Consists of review and responses to request for additional information concerning compliance with 10CFR50, Appendix G for the Duane Arnold Energy Center...

PLANT NAME: DUANE ARNOLD  
jcm 10/18/77

October 12, 1977  
IE-77-1875

FIGURE 1-2 BWR RADIATION EFFECTS DESIGN CURVE

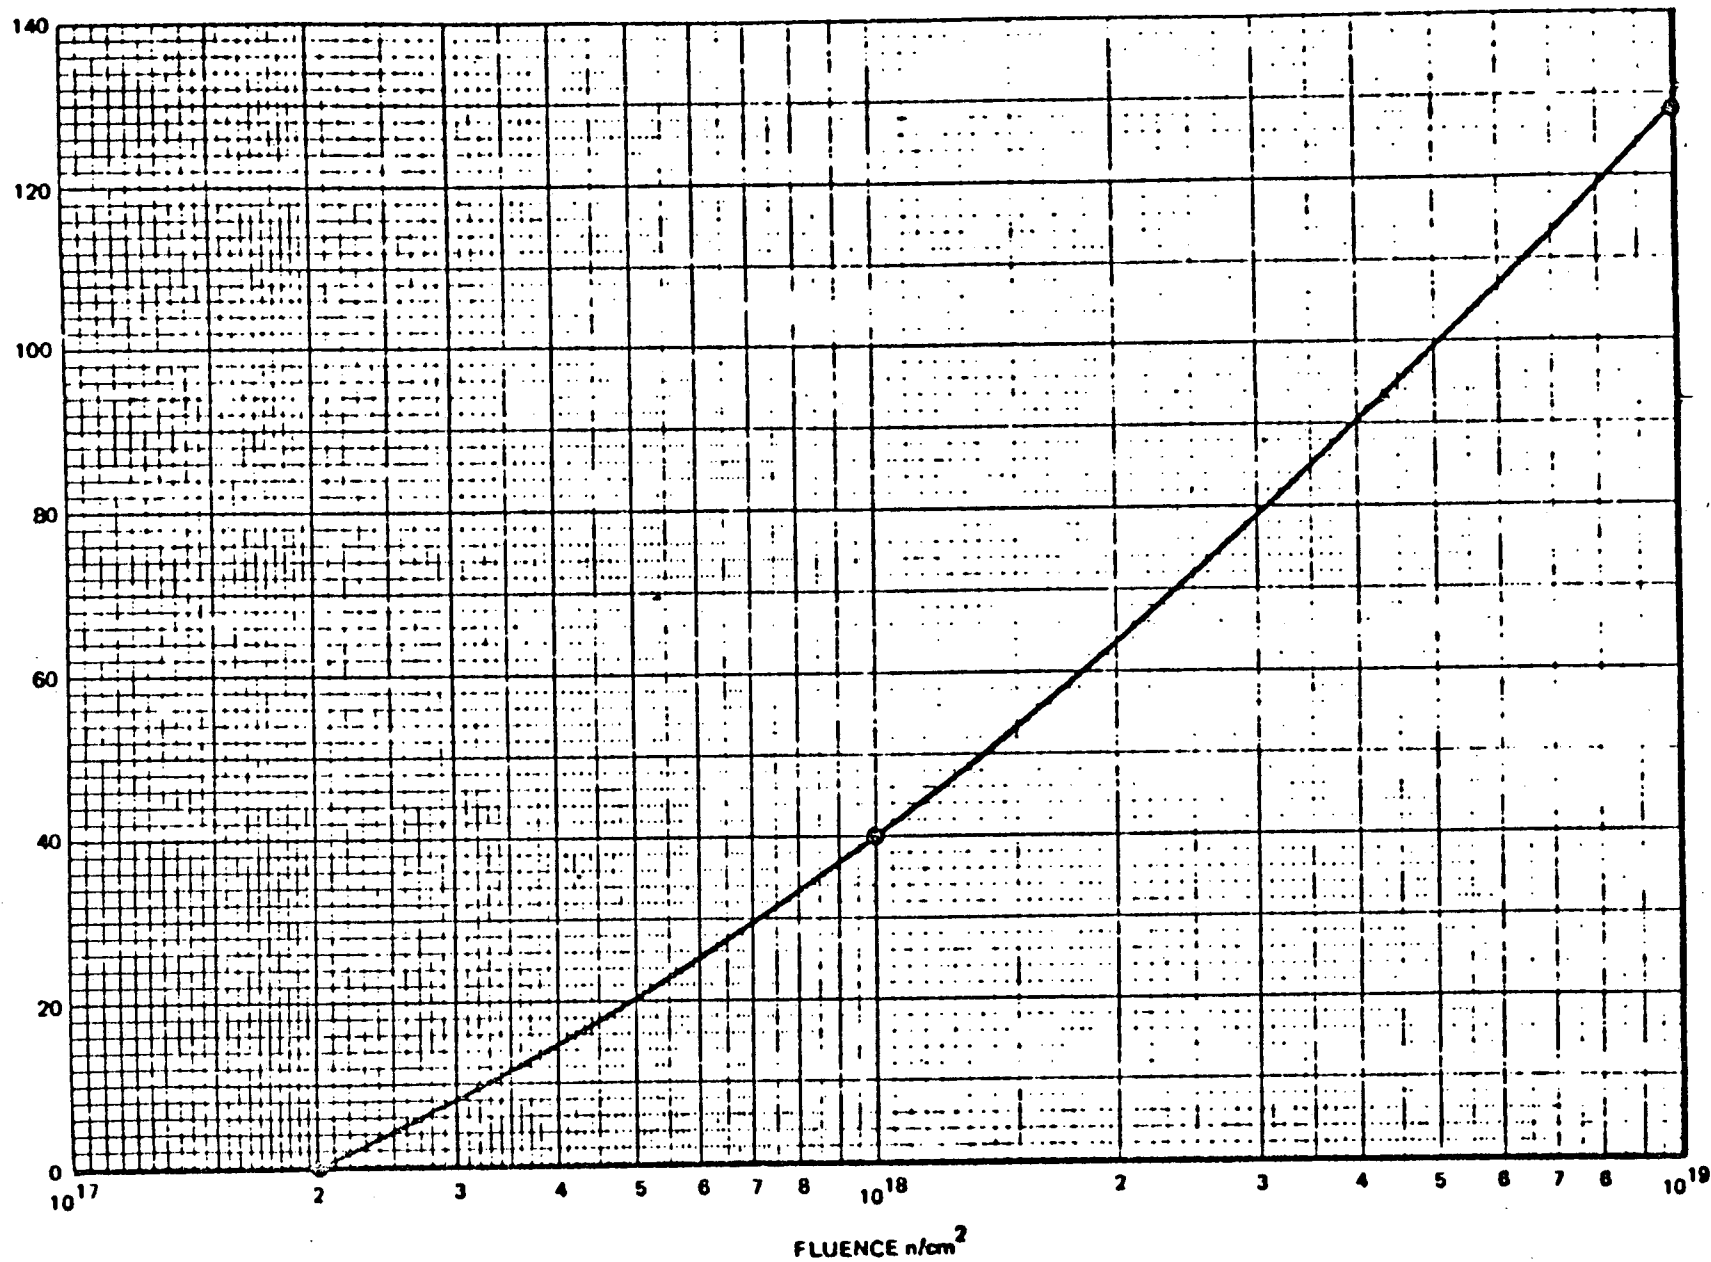
The change in transition temperature as a function of fluence shown in Figure 3.6.1 deviates from Regulatory Guide 1.99, "Effects of Residual Elements on Predicted Radiation Damage to Reactor Vessel Materials". Provide justification for the deviations.

The existing GESSAR curve for irradiation response of Reactor Pressure Vessel plate, forging, and weld metal is shown in Figure 1-2. All three product forms are governed by the same plot. The shift in temperature at which 30 ft-lbs is absorbed is the only attribute of the irradiation response curves described. Longitudinally oriented specimens were used to generate the plot. Surveillance data from four BWR's were used. Copper and phosphorous contents, which have been shown to govern irradiation response were not specifically evaluated but an overall upper bound curve was used. Almost all the data were collected over the fluence regime from

Figure 1. BWR/6 251 STANDARD PLANT- Minimum Temperature for Pressure Tests Such as Required by Section XI.

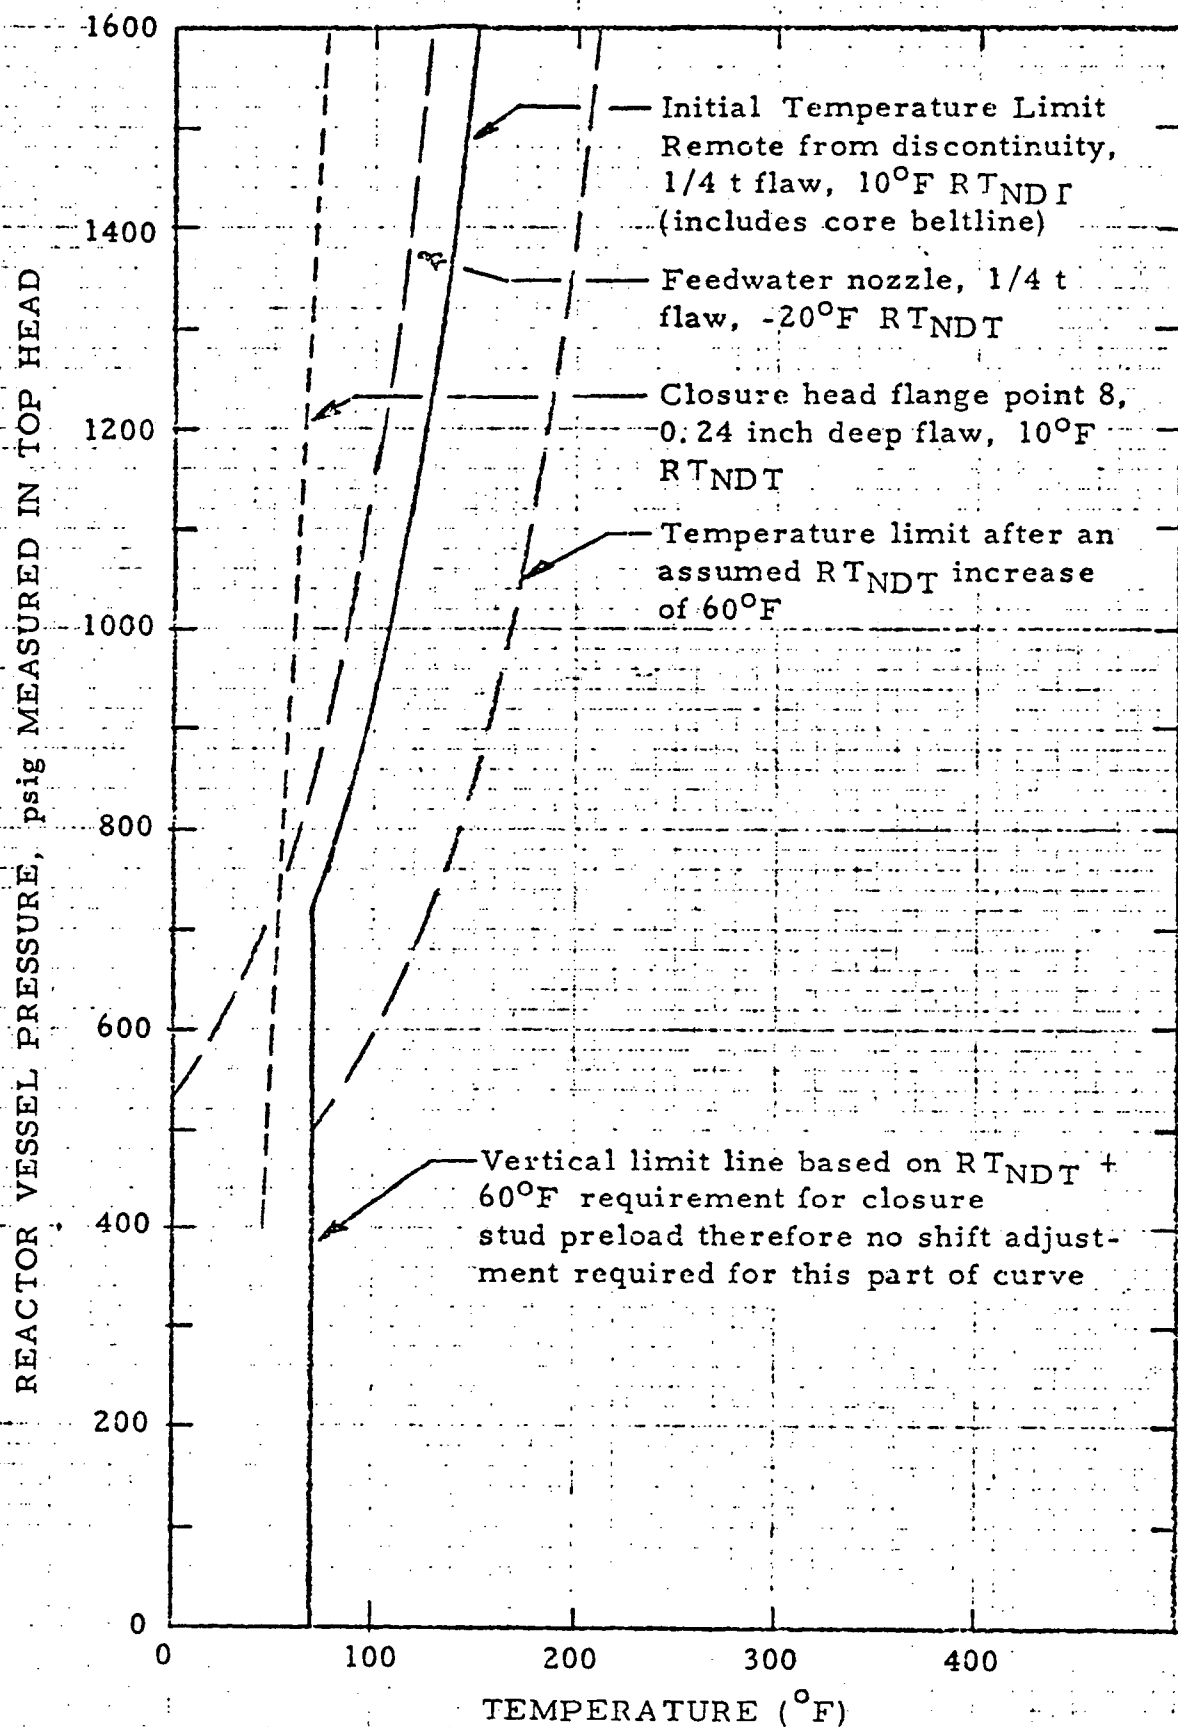
As stated in Branch Technical Position MTEB 5-2 (attached to NRC Standard Review Plan 5.3.2), Positions 2.2.1 and 2.2.2, the staff requires calculations of pressure-temperature limits for regions other than the beltline unless the  $RT_{NDT}$  of the beltline is at least 50° F above the  $RT_{NDT}$  for all higher stressed regions. Please submit calculations of pressure-temperature limits for higher stressed regions or provide documentation that shows the  $RT_{NDT}$  of the beltline is at least 50° F above the  $RT_{NDT}$  for all higher stressed regions.

Figure 1 shows that the limits for regions remote from discontinuities (with an assumed 1/4t flaw) do provide reasonable temperature-pressure limits for pressure tests provided the  $RT_{NDT}$  of the nozzles is at least  $30^{\circ}$  below the  $RT_{NDT}$  of the regions remote from discontinuities. With this  $30^{\circ}$  difference, the feedwater nozzle results closely correspond to those derived for the region remote from discontinuities. The flange results shown on Figure 1 are based on the ability to detect a surface crack which is equal to or less than 0.24 inches deep at the outer junction of the head with the flange (at point 8 as shown on Figure 6). A 1/4t crack can be accommodated in the flange discontinuity regions except at surface location points 8, 18, and 20 shown in Figure 6. A crack of 0.24 inch depth can easily be detected by outside surface examination techniques at these locations. Summarizing, the flange results are not limiting compared to the limits for the region remote from discontinuities with a 1/4t flaw because it is possible to detect a flange discontinuity flaw smaller than 0.24 inch depth at the locations of concern by surface examination methods. Also, volumetric examination methods can be used for supplemental evaluation. The curves derived for regions remote from discontinuities are satisfactory for pressure tests provided the nozzle  $RT_{NDT}$  is at least  $300^{\circ}F$  below that for the remote regions.
